# MAGNOLIA MIXED USE

DPD Project #3035295-LU

Recommendation Meeting  
West Design Review Board

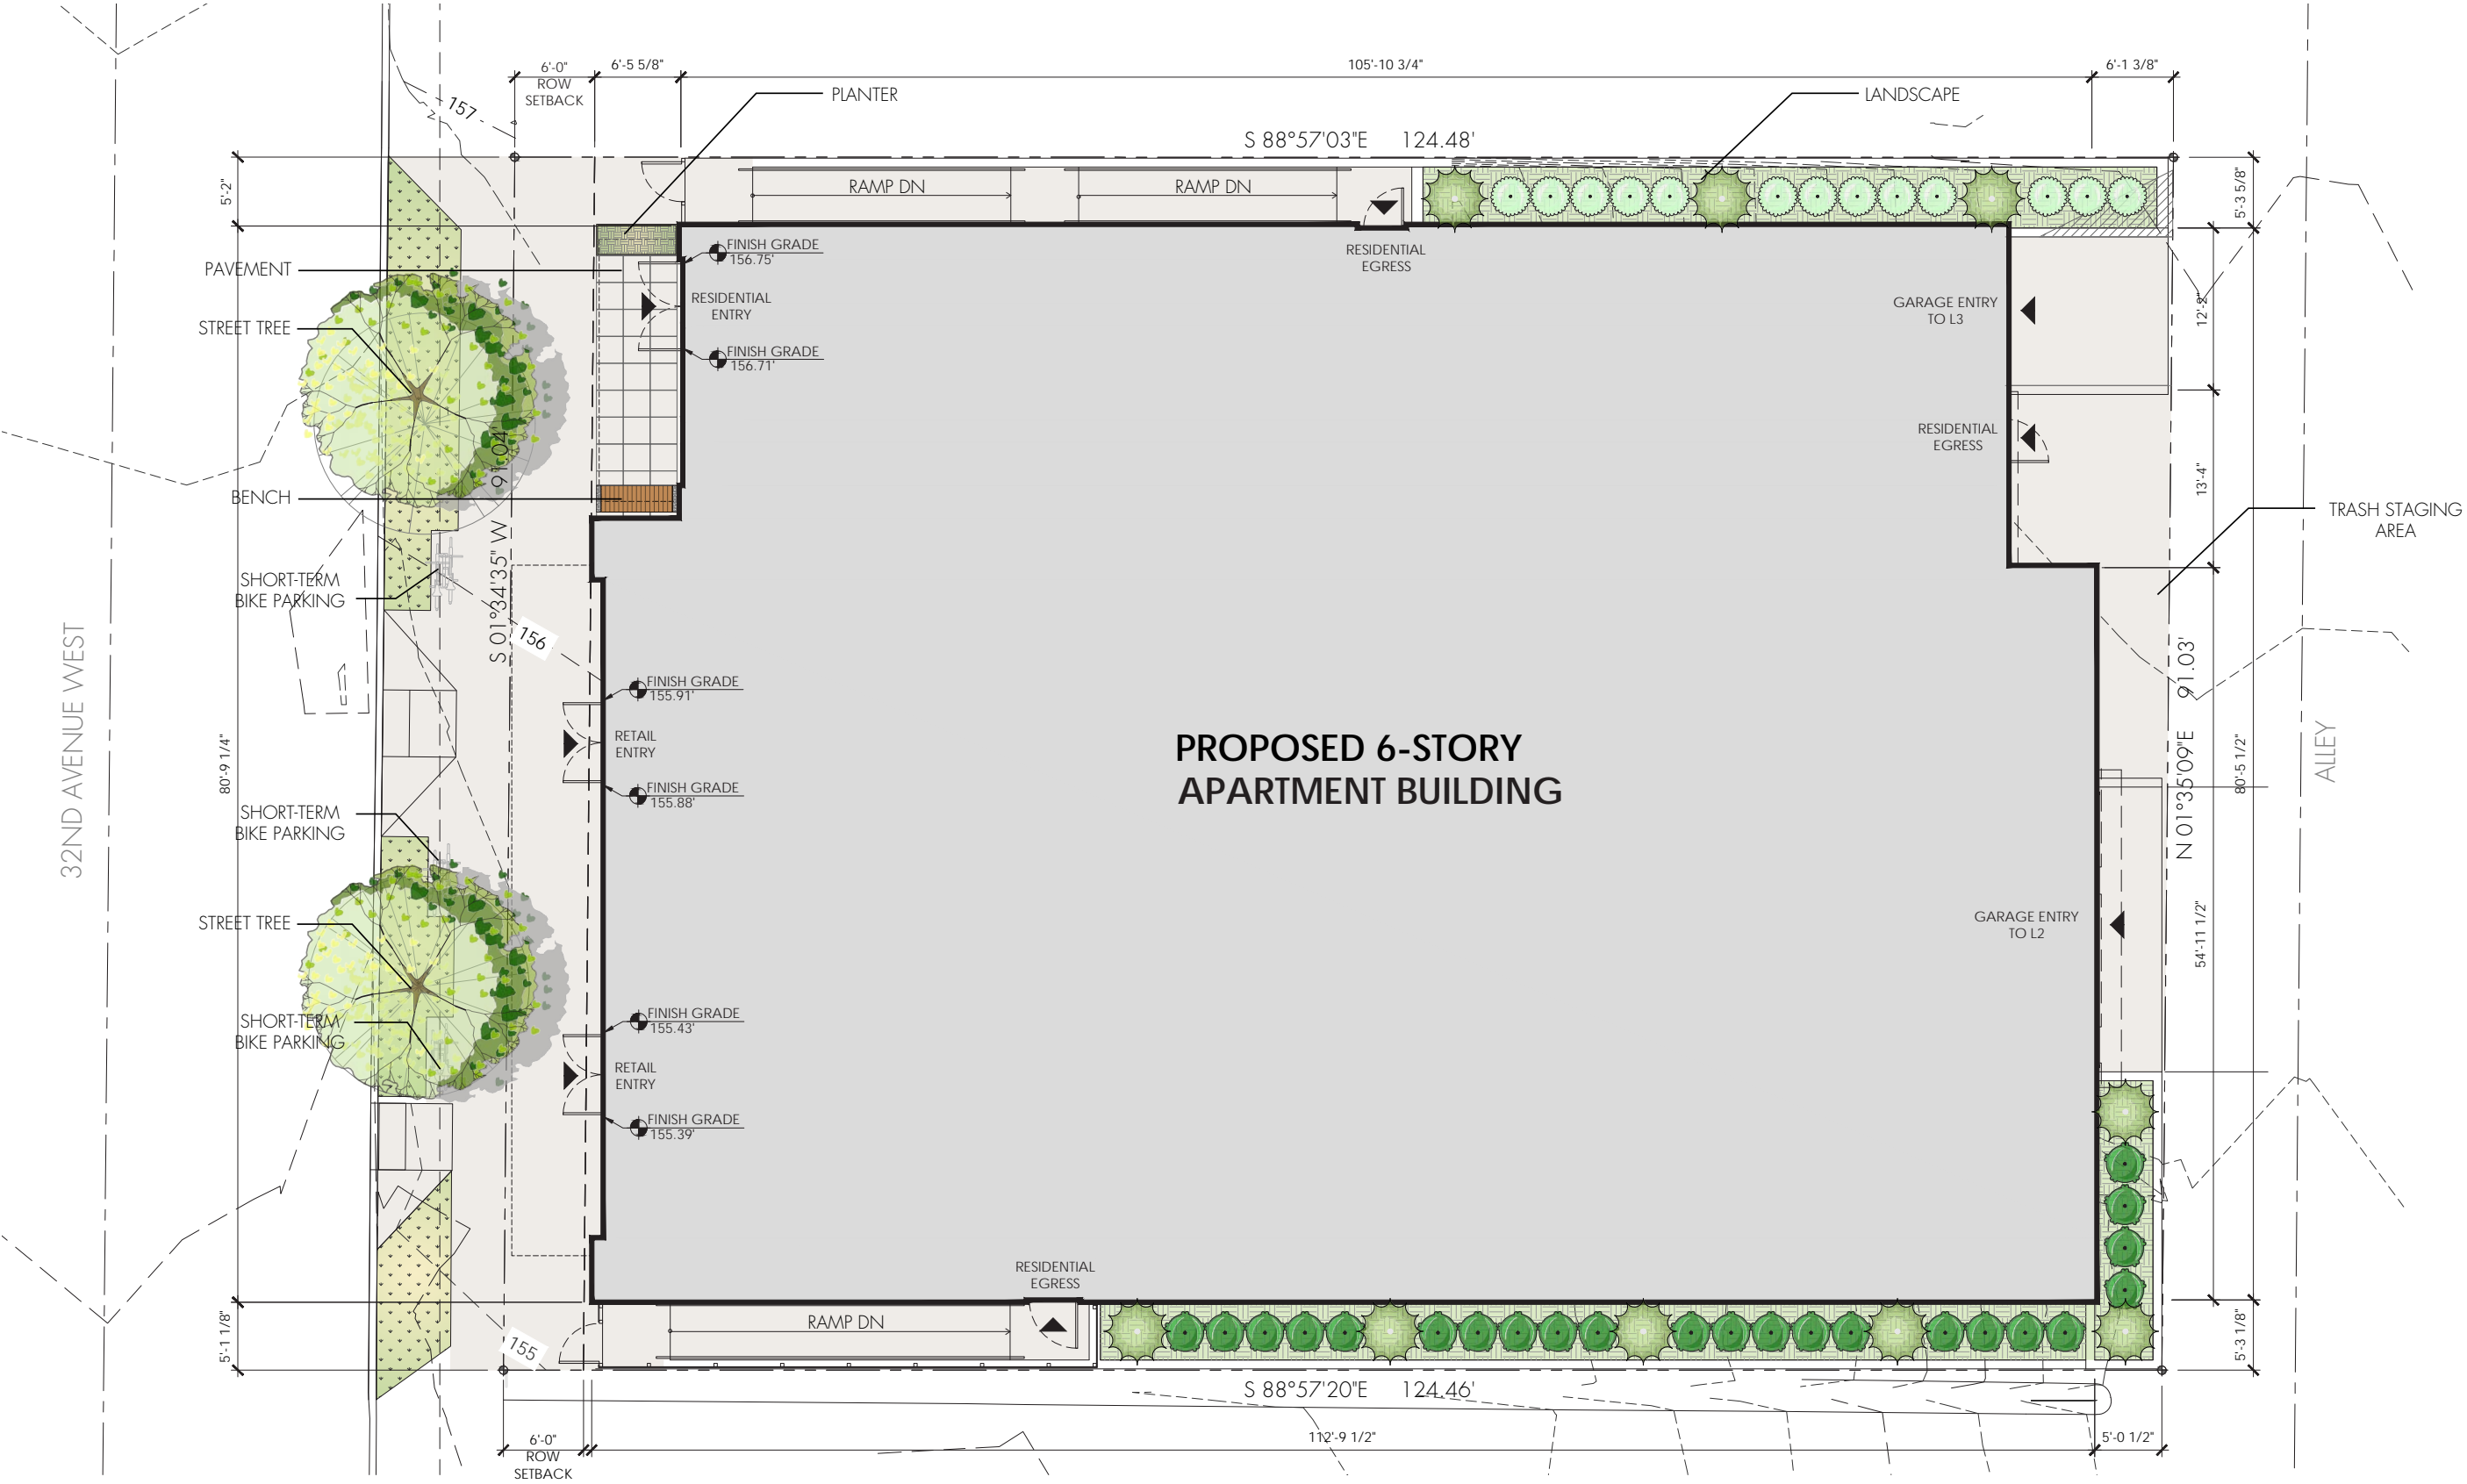
b. The Board expressed concern that the presence of the parking area would interrupt the concept expression of the south façade, and emphasized the need for the south façade to be treated with a consistent expression that achieves architectural unity between the lower floors along the parking area and the residential upper floors (CS2-D-1. Existing Development and Zoning, CS2-D-5. Respect for Adjacent Sites, CS3-A. Emphasizing Positive Neighborhood Attributes).

Per the Board's recommendation the lower levels of the south façade have been treated to be consistent with the upper levels by having the same opening sizes with mesh infill panels and similar accent materials.
